1985 RX-7 & 1984 B2000/B2200

SUBJECT Roller Bearing & Main Shaft.

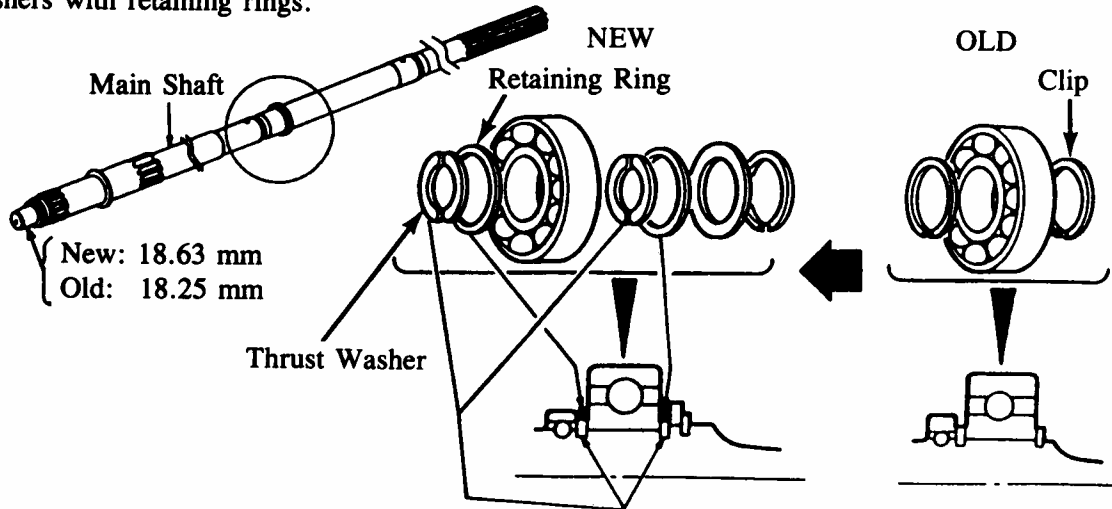
1. The roller bearing has been enlarged and the recess in the main drive gear has been enlarged to accept the new roller bearing.

2. The method of retaining the bearing on the main shaft has been changed from clips to thrust washers with retaining rings.
